ADDENDUM NO. 4
September 5, 2024

Customs and Border Protection (CBP) Federal Inspection Service (FIS) Facility Renovation
City of Duluth Project No. 24-4401
Duluth International Airport
Duluth, MN

SEH No. DULAI 170389

SECOND LEVEL TELECOMMUNICATIONS FLOOR PLAN - AREA A

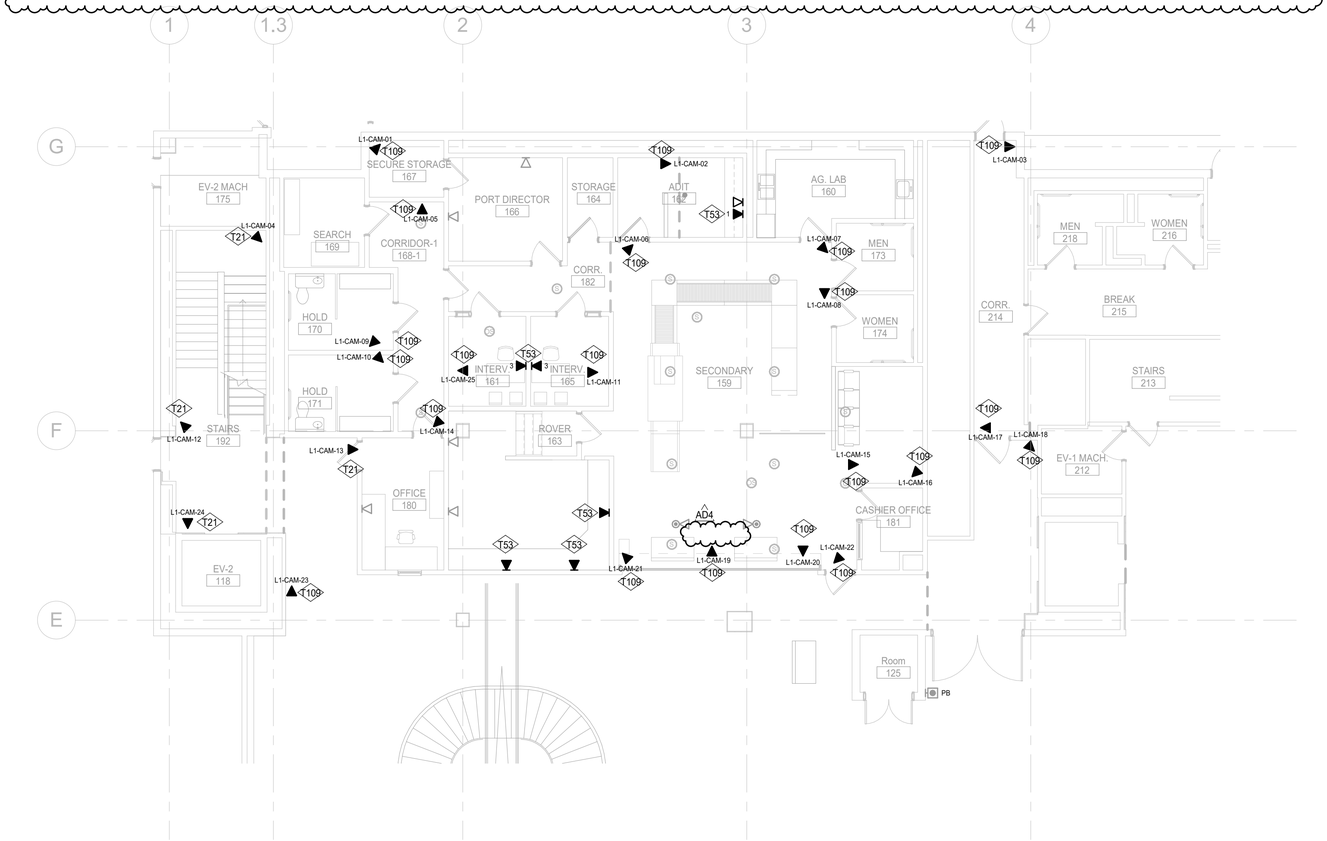
c) Added view for the tug drive.
    d) Added (1) data for new camera in the tug drive.
11. T200 – SECOND LEVEL TELECOMMUNICATIONS FLOOR PLAN – AREA A

a) Revised general notes.
    b) Moved (1) new data for camera onto the passenger ramp.
    c) Added (3) new data for cameras onto the passenger ramp.

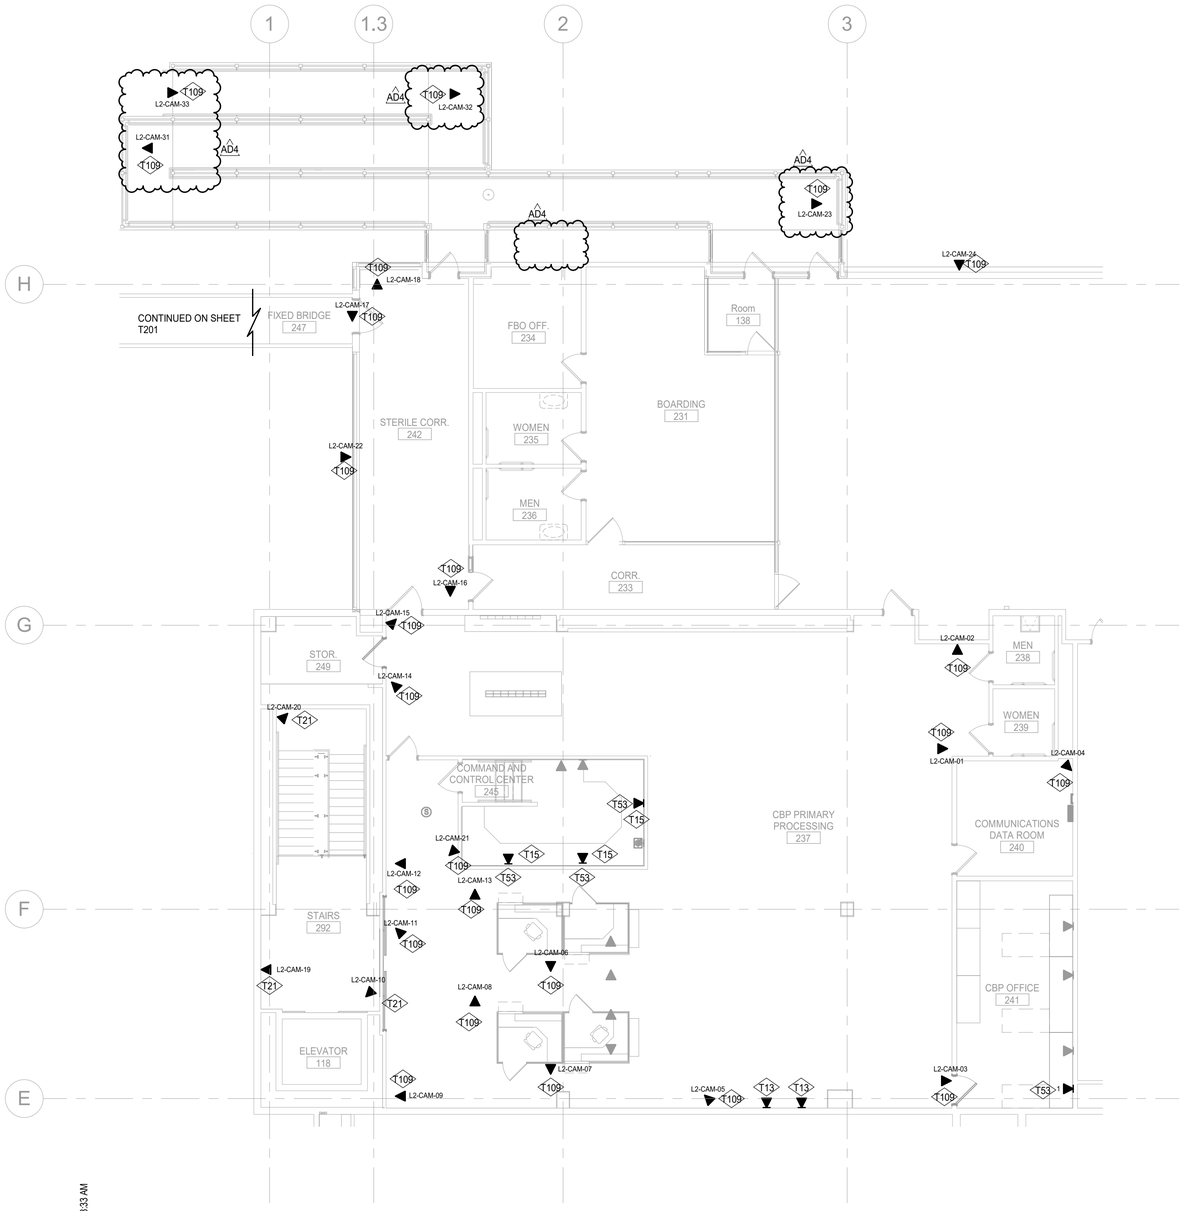
12. T201 – SECOND LEVEL TELECOMMUNICATIONS FLOOR PLAN – PASSENGER BOARDING BRIDGE
    a) Revised general notes.
    b) Added (2) new data for cameras underneath the passenger boarding bridge.
